**REZONING, PUD &
SUBDIVISION STAFF REPORT**

Date: July 10, 2003

Springhill-Louiselle Subdivision

SITE PLAN

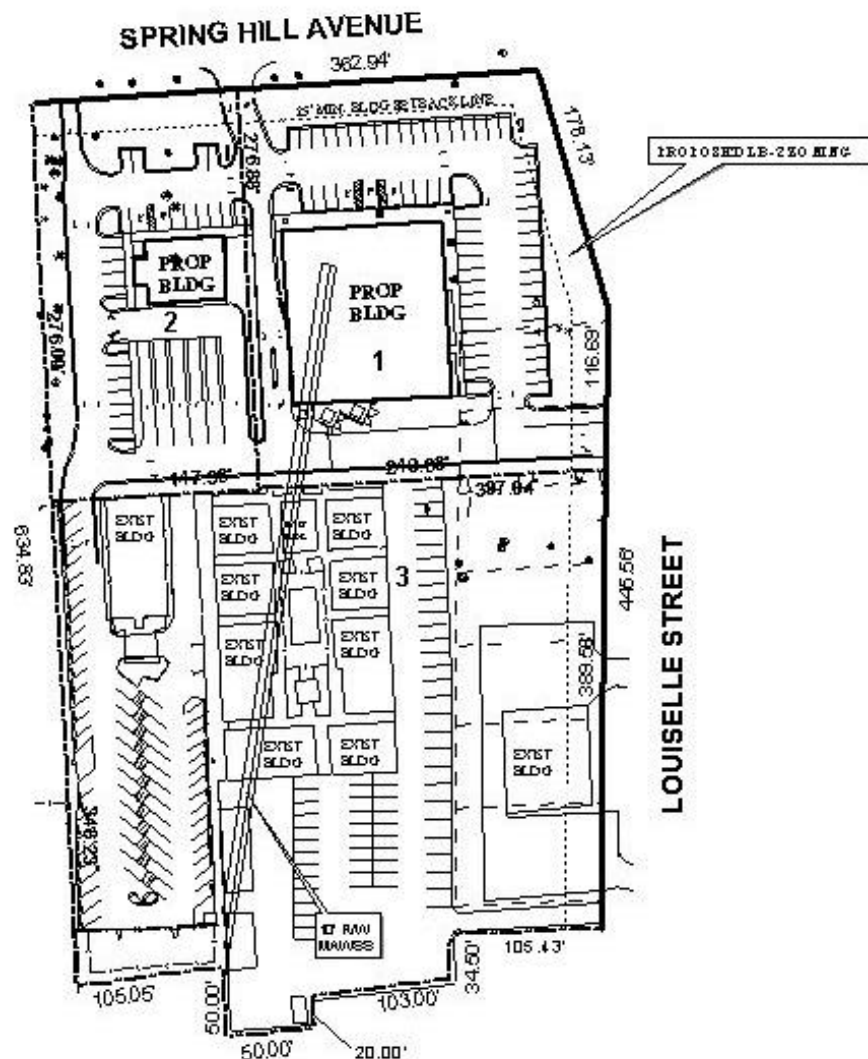
The plan illustrates the construction of the proposed drug store and new bank facility, which have shared access and circulation. The PUD also encompasses existing developments, part

Generally, the proposal appears to meet the standards for PUD approval. However, there are a few points which should be addressed. The first is that of buffering. While the entire site is zoned B-1, a portion of proposed Lot 3 is developed with multi-family dwellings. Buffering between the new development and the multi-family development would be appropriate.

The plan submitted illustrates a “sign easement” for the bank property on the Louiselle Street frontage. This would not only be an off-premise sign, but would also be a second sign for the bank – both of which would be in violation of the sign regulations. The applicant(s) should be made aware that if the PUD is approved, the approval would not automatically permit the second sign; a variance from the Board of Zoning Adjustment would be needed for any signage that does not comply with the sign regulations.

As stated previously, Lot 3 incorporates multiple existing developments (office buildings and a multi-family complex) into one lot. The development(s) located on this lot should not have a significant impact on the new development. However, any future redevelopment of Lot 3 will require an amendment to the PUD.

Planned Unit Development: based on the preceding, it is recommended that this application be approved, subject to the following conditions: 1) driveway number, sizes, location and design to be approved by Traffic Engineering and conform to AASHTO standards; 2) completion of the accompanying rezoning and subdivision applications; 3) full compliance with Urban Forestry Comments (All work within the critical root zone of the trees on existing right-of-way is to be permitted by the Mobile Tree Commission; ingress and egress to be coordinated with Urban Forestry; 60” Live Oak that is on developed property is to be given preservation status; alternative paving surfaces to be used on the South side of the 60” Live Oak; all work on existing city owned trees or 24” and larger Live Oak trees on developed site is to

be coordinated with Urban Forestry); 4) future redevelopment of Lot 3 will require amendment to the PUD; 5) closure (including removal and installation of curbing and landscaping) of “abandoned” existing curb cuts; 6) full compliance with all municipal codes and ordinances.

As a side note, it is also recommended that the applicant(s) be advised that PUD approval does not sanction or permit the off-premise, second sign for Lot 2 – variances from the Board of Zoning Adjustment will be required.

SPRINGHILL - LOUISELLE SUBDIVISION

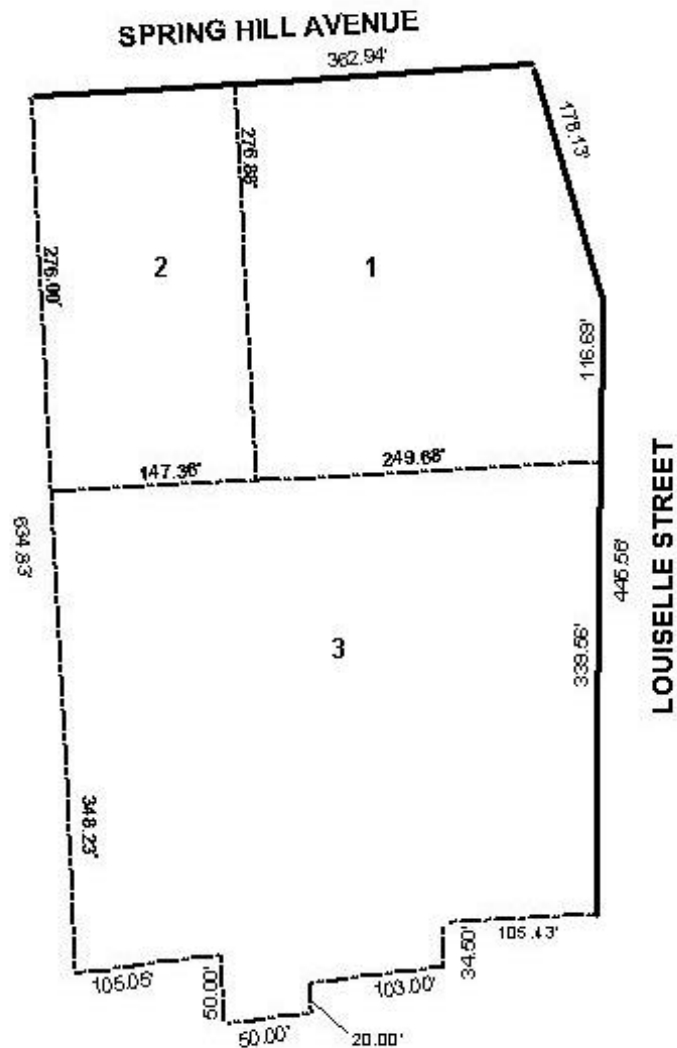
Significant drainage issues need to be resolved prior to Engineering approval of subdivision plat and development permitting. Many stormwater drainage features of the site are not shown on the preliminary plat and should be shown. Some noted during a site visit include: drainage onto lot 3 from the property to the south, several stormwater inlets in parking lot of lot 3, ETC. Based on Engineering Department information, the stormwater culvert conveying Little Stickney creek is located beneath the parking lot of lot 3 and should be shown on the plat. Due to extensive flooding in the area, Engineering will require stormwater detention for all impervious area on the newly developed sites. Must comply with all stormwater and flood control ordinances. Any work performed in the right of way will require a right of way permit.

With regard to the proposed subdivision, the plat meets the minimum requirements of the Subdivision Regulations.

Subdivision: the plat meets the minimum requirements of the Subdivision Regulations and is recommended for Tentative Approval, subject to the following conditions: 1) placement of a note on the final plat stating that driveway number, sizes, location and design to be approved by Traffic Engineering and conform to AASHTO standards; and 2) placement of a note on the final plat stating that the 60’ oak located on Lot 2 has preservation status; and 3) provision of buffering along property lines between commercial and residentially developed properties, including property lines within the subdivision.
